Attachment: Replacement Sheet
Annotated Sheet Showing Changes

Figure 1

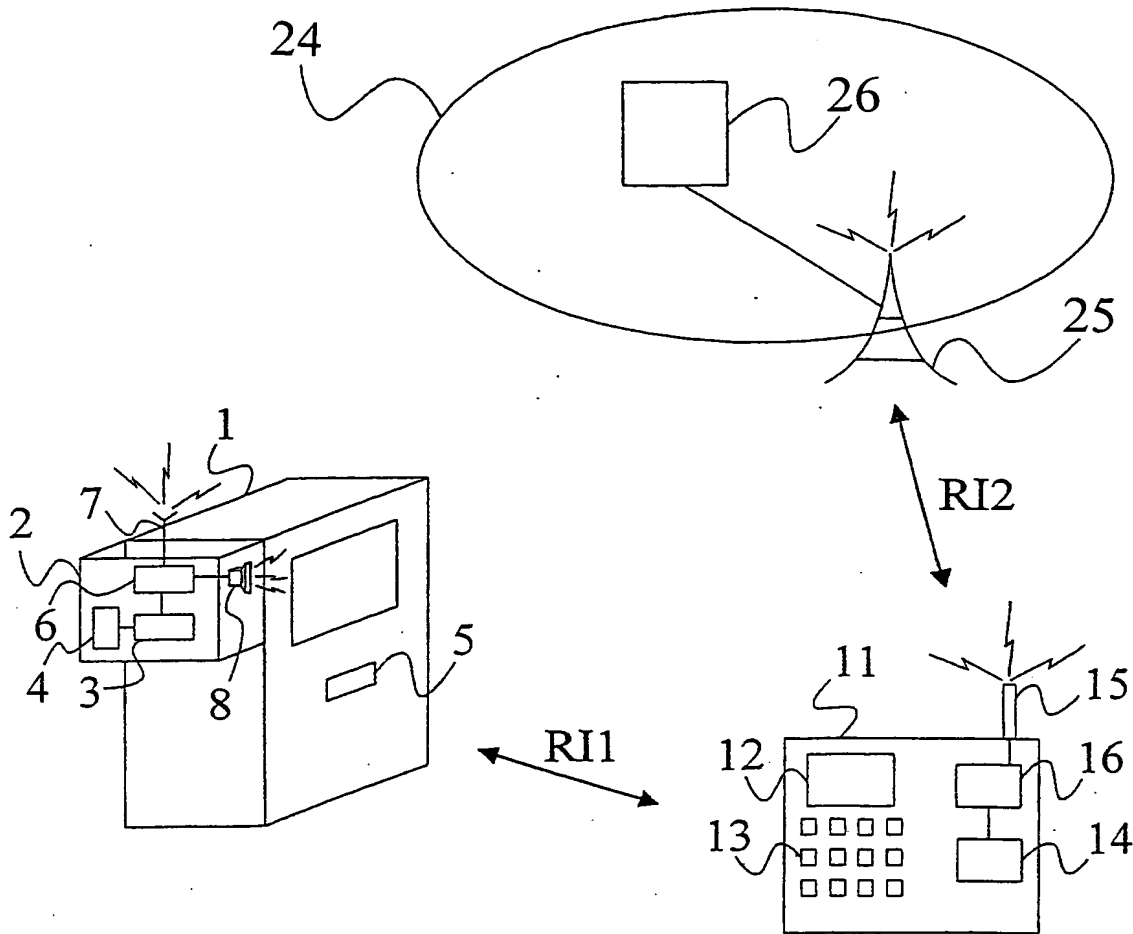
Please **REPLACE** Figure 1 of the drawings with amended Figure 1 on the attached sheet. In Figure 1, reference numerals 14, 15, and 16 for the cellular network, Base Station Subsystems, and Mobile Switching Centre, would be changed to reference numerals 24, 25, and 26, respectively.
